PUBLIC INTEREST REVIEW FOR GROUNDWATER APPLICATIONS

SUBJECT: Application G- 17480 Supersedes review of _____ Date of Review(s)

A. GENERAL INFORMATION: Applicant's Name: William & Rosa Rupp County: Umatilla

A1. Applicant(s) seek(s) 2.0 cfs from 2 well(s) in the Umatilla River Basin, Birch Creek subbasin Quad Map: Pilot Rock & Sevenmile Creek

Groundwater Application G-17480, Rupp Umatilla County, Pilot Rock & Sevenmile Creek Quads

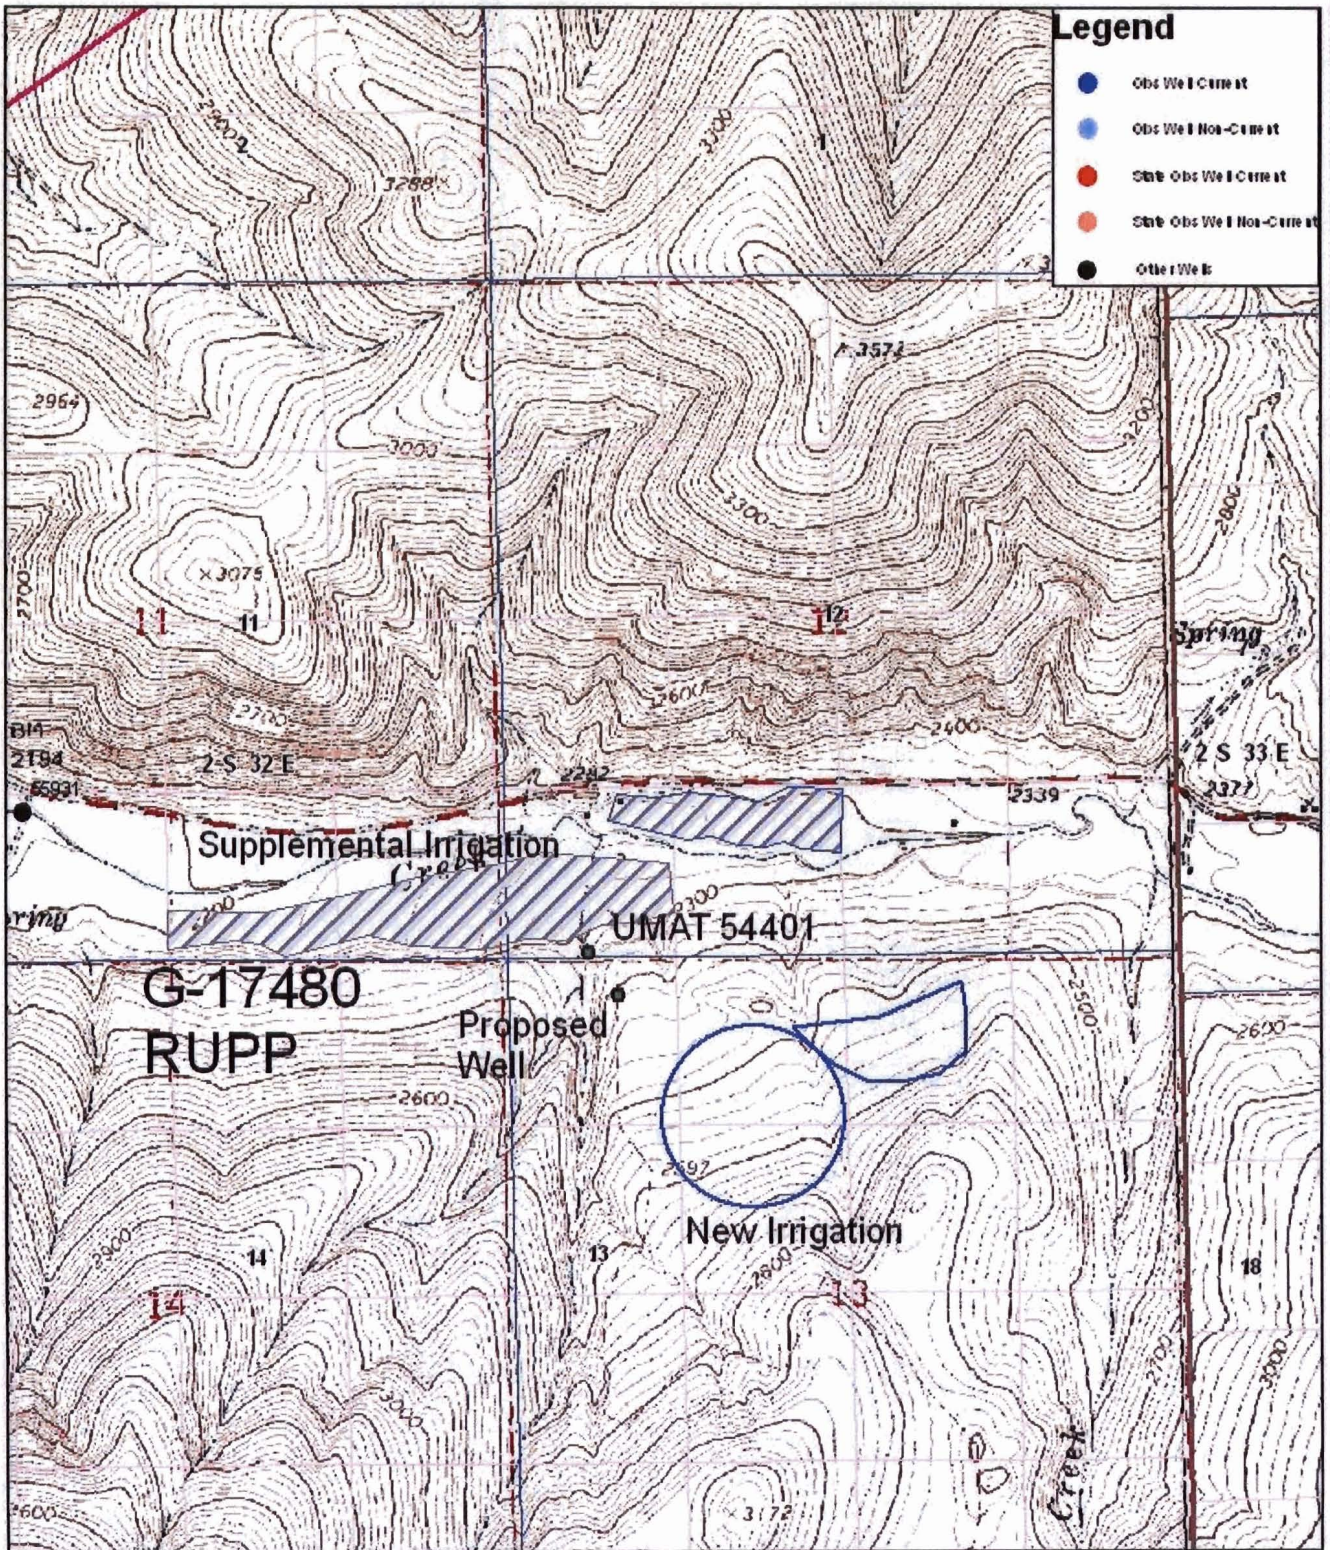
Greater well yields are possible if the well were constructed in the Columbia River Basalts as shown on the attached map. The well would need to be located at some distance away from the contact to increase the probability of developing water from the basalts.
